Technical Bulletin

Accessory drive on Renault 1.5 DCi engines

GATES REFERENCE :	Accessory drive	
MAKE :	RENAULT	
MODEL :	Clio II, Express, Kangoo, Rapid, Symbol	
MOTOR :	1.5 dCi	
MOTOR CODE :	K9K700, K9K702, K9K710

Fig.1

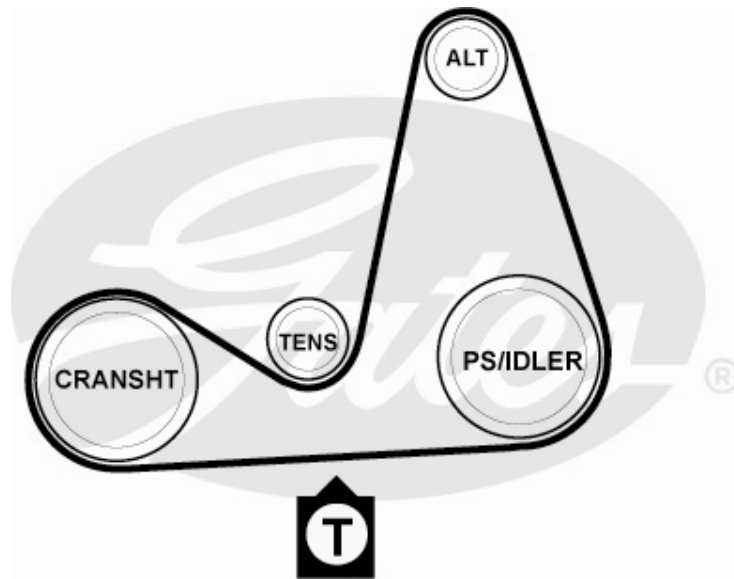
Measure the tension in the bottom span, between the crankshaft and power steering pump (or idler for cars without power steering) (Fig.1).

When measuring the belt tension with the STT-1, key in "8", "180" (virtual span of 180 mm). When measuring with the Krikit[®], tension has to be 70 Kg.

Now tighten the 2 bolts (36 Nm).
Rotate the engine 2 revolutions clockwise.
